## SERVICE INFORMATION NO. SI 20-085

Rotax Service Bulletin No. SB-912-073 Replacement of circlip (carburetor)

# SERVICE BULLETIN

## Replacement of circlip (carburetor) for ROTAX® Engine Type 912 and 914 (Series)

Fig. 5

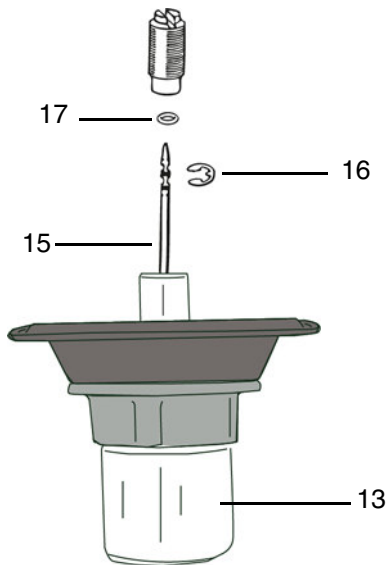
Step	Procedure
6	Remove jet needle (15) with circlip and O-ring from piston assy. (13).
7	Remove original O-ring (17) and circlip (16) from the jet needle (15) and discard. NOTE: Take note of the circlip's original needle position.

Fig. 6

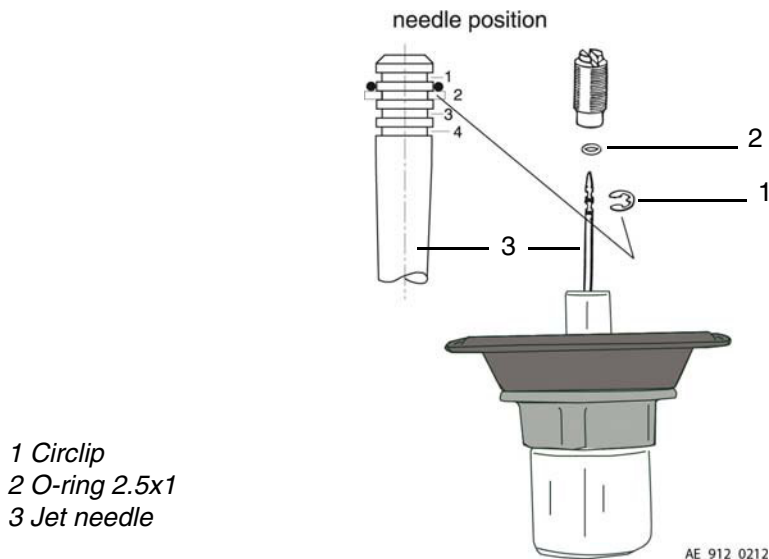
Step	Procedure
1	Place a new circlip part no. 945786 (1) into the same needle position. Place a new O-ring 2.5x1 part no. 950430 (2) over the jet needle (3).
